Access Compliance Report

Public Rights-of-Way

(Curb Ramps)

Intersection ID: 53001	Main Street: GRANT_MARTIN_DR	Cross Street: JACOB_ALEXANDER_CT	Location:	N
ADA ID: 88AA2575C0FF	Ramp Type: PerpDiag	Initial Pass/Fail: Fail	Overall Compliance: No	Severity Score: 8.75
Codes/Mitigation Info/Possible Solution		Field Measurements/Component Compliance

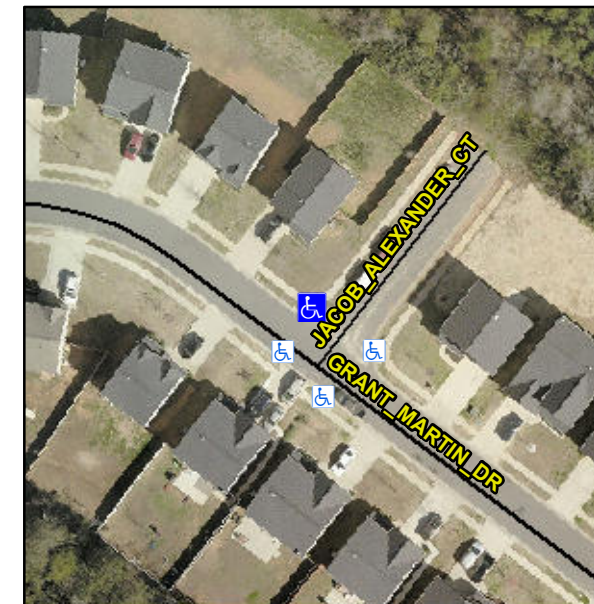
Possible Solutions:

Remove & Replace Curb Ramp With Two New Directional Ramps or Equivalent.

PROW/ADA:

Not Found, R304.5.1
